Access Compliance Report

Public Rights-of-Way

(Curb Ramps)

Intersection ID: 11882	Main Street: N_PINE_ST	Cross Street: W_5TH_ST	Location:	E
ADA ID: 823C27472A7C	Ramp Type: Perp	Initial Pass/Fail: Fail	Overall Compliance: No	Severity Score: 25
Codes/Mitigation Info/Possible Solution		Field Measurements/Component Compliance

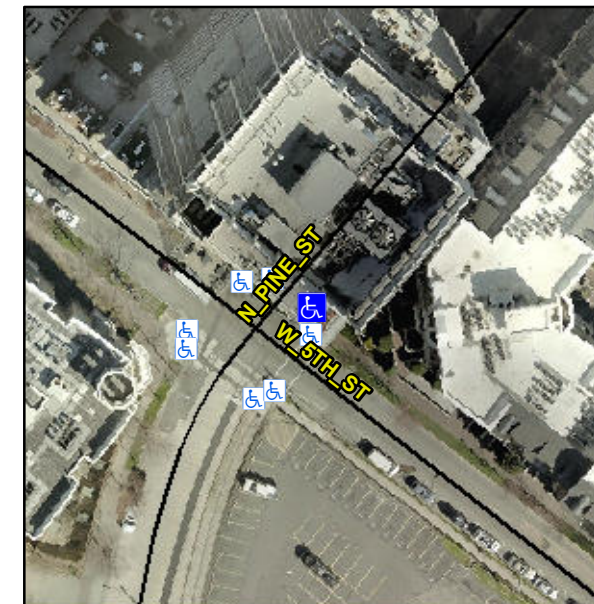
R304.2.2, R304.5.3

Compliance	Description	Data	Compliance	Description	Data
N/A	Ramp Length (in)	74.0	No	Ramp Slope (%)	11.2
Yes	Ramp Width (in)	60.0	No	Ramp XSlope (%)	6.3
N/A	Flare Type LT	N/A	N/A	Flare Type RT	N/A
N/A	Flare Slope LT (%)	N/A	N/A	Flare Slope RT (%)	N/A
N/A	Flare Traversable LT?	N/A	N/A	Flare Traversable RT?	N/A
N/A	Landing Length (in)	N/A	N/A	DWS Provided?	N/A
N/A	Landing Width (in)	N/A	N/A	DWS Contrast?	N/A
N/A	Landing Slope (%)	N/A	N/A	DWS Length (in)	N/A
N/A	Landing X Slope (%)	N/A	N/A	DWS Full Width?	N/A
N/A	Landing Curb? (Y/N)	N/A	N/A	DWS Offset (in)	N/A
N/A	Shared Landing?	N/A			
N/A	Gutter Ponding?	N/A	N/A	Gutter Slope (%)	N/A
N/A	Gutter Lip Ht (in)	N/A	N/A	Gutter X Slope (%)	N/A
N/A	Painted X Walk1?	Yes	N/A	Painted X Walk2?	N/A
	X Walk 1 Direction	To NW		X Walk 2 Direction	N/A
N/A	X Walk 1 Width (in)	100.0	N/A	X Walk 2 Width (in)	N/A
	X Walk 1 Slope (%)	2.6		X Walk 2 Slope (%)	N/A
	X Walk 1 X Slope (%)	6.9		X Walk 2 X Slope (%)	N/A

Remove & Replace Entire Ramp.
